CONFIG Packet

Formatting on 32 bit boundaries

Disclosure: Intellitech Ethernet Scan and Systembist

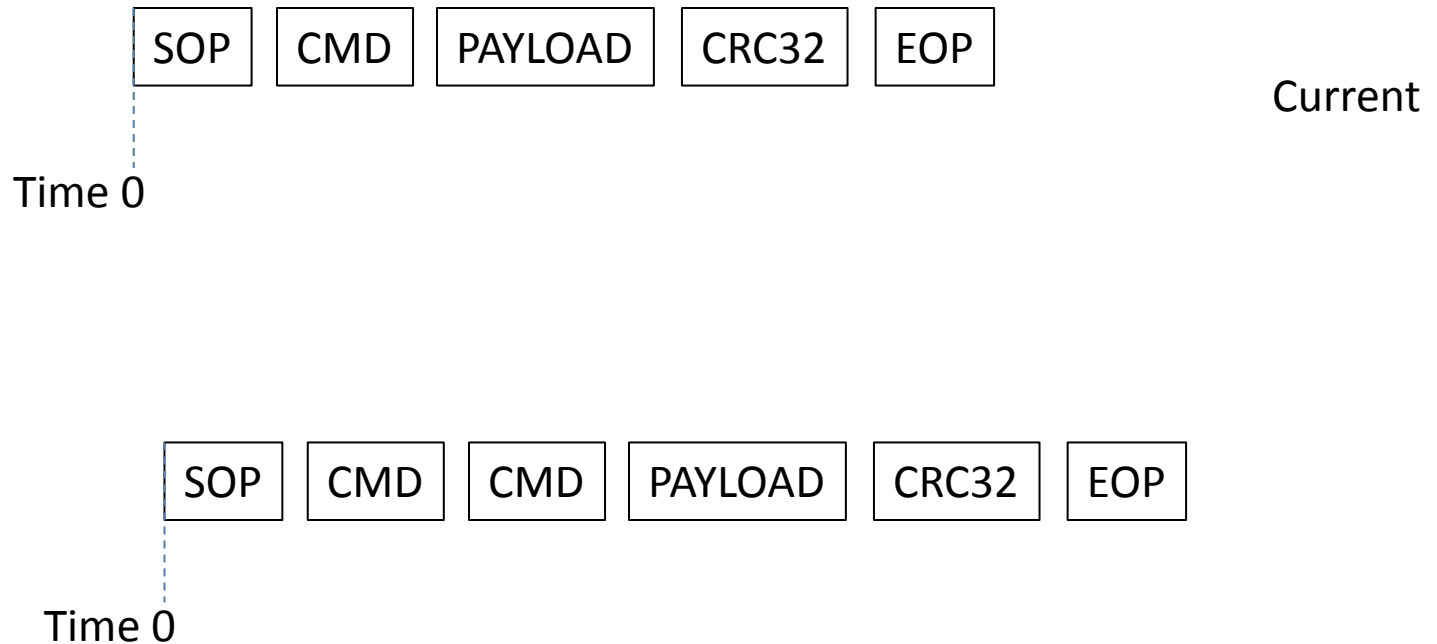
Are two commands too much overhead?

- padding of packet plus more CMD checking

- Do SPI folks think this is too much redundancy?

Additional CMD byte allows CRC32 to be unsplit.
Is that a 'human' thing or is there a significant logic savings?

Use 32 bit boundaries for all packets. - Not trying to push one solution over another. Just trying to offer workable solution.

As Written

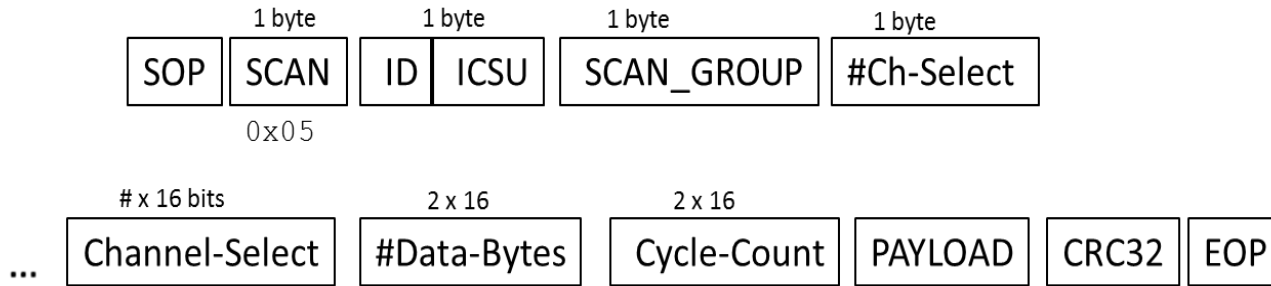
Note Two
Channel select
Words.

Odd number of
Channel-Select
Words and
#data-bytes,
Cycle count
And CRC are not split
Over 32 bit boundary

As Written

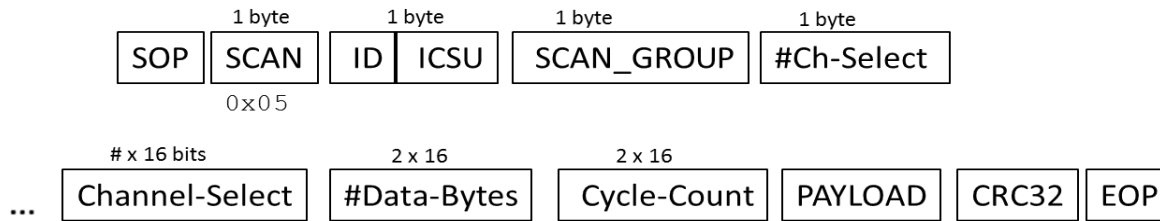
Extend DATA_SIZE to Channel-Select, SOP and EOP?
IDLE or PAD?

Format IDLEs to DATA_SIZE?

64/66 + Limit #Ch-Select to be EVEN? **NO**
 Otherwise have to pad out to 32 bits

DATA_SIZE = 32

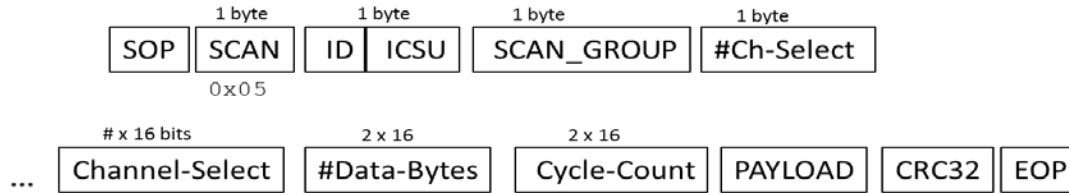
Force SOP/EOP to 32 bits?
 Limit #Ch-Select to be EVEN?
 Otherwise have to pad out to 32 bits

Odd number of
 Channel-Select
 Words and
 #data-bytes,
 Cycle count
 And CRC are split
 Over 32 bit boundary

DATA_SIZE = 32
 Force IDLE to be 4 bytes as well?

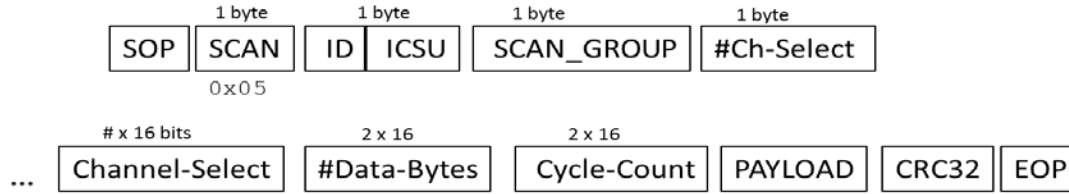
Force SOP/EOP to 32 bits?
 Limit #Ch-Select to be EVEN?
 Otherwise have to pad out to 32 bits

Odd number of
 Channel-Select
 Words and
 #data-bytes,
 Cycle count
 And CRC are split
 Over 32 bit boundary

DATA_SIZE = 64
 Force IDLE to be 4 bytes as well?

Alternative approach: EOP/SOP must appear within four IDLES
